APPLICATION NO.	FILING DATE	FIRST NAMED INVENTOR	ATTORNEY DOCKET NO.	CONFIRMATION NO.
10/025,904	12/26/2001	Yong Ik Bang	8733.525.00	7612
30827	7590	01/16/2004		
MCKENNA LONG & ALDRIDGE LLP 1900 K STREET, NW WASHINGTON, DC 20006				
			EXAMINER RUDE, TIMOTHY L	
			ART UNIT 2871	PAPER NUMBER

Office Action Summary	Application No.	Applicant(s)	
	10/025,904	BANG ET AL.	
	Examiner	Art Unit	
	Timothy L Rude	2871

DETAILED ACTION

FIG. 1

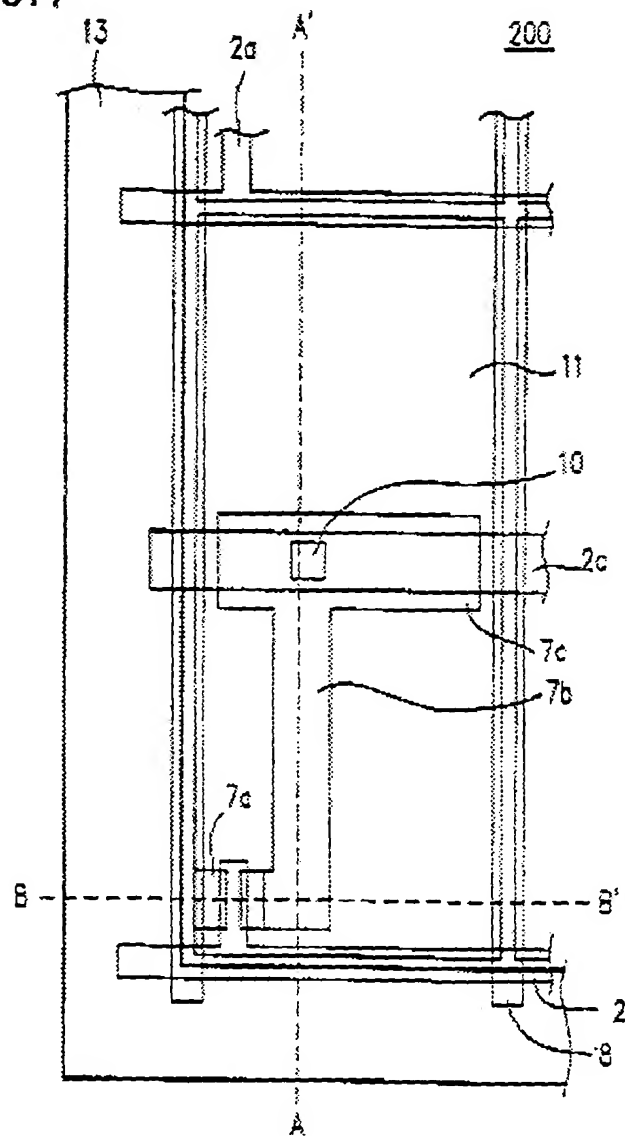
2. Claim 1 is rejected under 35 U.S.C. 102(b) as being anticipated by Shimada et al (Shimada) USPAT 5,877,830.

As to claim 1, Shimada discloses (Title, Abstract, entire patent) a liquid crystal display (LCD) panel comprising:

a first substrate provided with a plurality of gate, 2, and data, 8, lines, the gate lines being arranged to cross the data lines to define a plurality of pixel regions in a matrix

arrangement; a second substrate provided with a black matrix layer (col. 5, lines 50-60) to shield portions other than the pixel regions from light; and liquid crystal layer injected between the first and second substrates, wherein the pixel regions in a peripheral portion of the matrix arrangement has an aperture ratio lower than that of the pixel regions in other portions of the matrix arrangement (col. 6, lines 35-45) in the example where the black matrix overlaps the pixel electrodes, 11.

FIG. 5

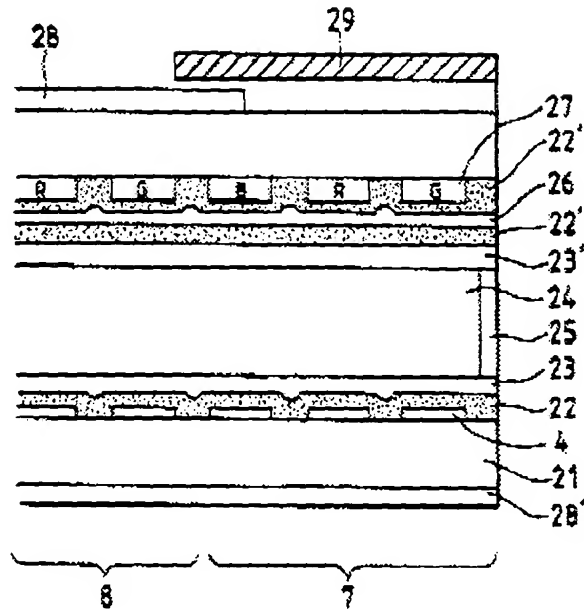
3. Claim 1 is rejected under 35 U.S.C. 102(b) as being anticipated by Sono et al (Sono) USPAT 5,513,028.

As to claim 1, Sono discloses (Title, Abstract, entire patent) a liquid crystal display (LCD) panel comprising:
a first substrate provided with a plurality of gate and data lines, the gate lines being arranged to cross the data lines to define a plurality of pixel regions in a matrix arrangement; a second substrate provided with a shield plate, 29 (Applicant's black matrix layer), to shield portions other than the pixel regions from light; and liquid crystal layer injected between the first and second substrates, wherein the pixel regions in a peripheral portion of the matrix arrangement has an aperture ratio lower than that of the pixel regions in other portions of the matrix arrangement due to shielding.
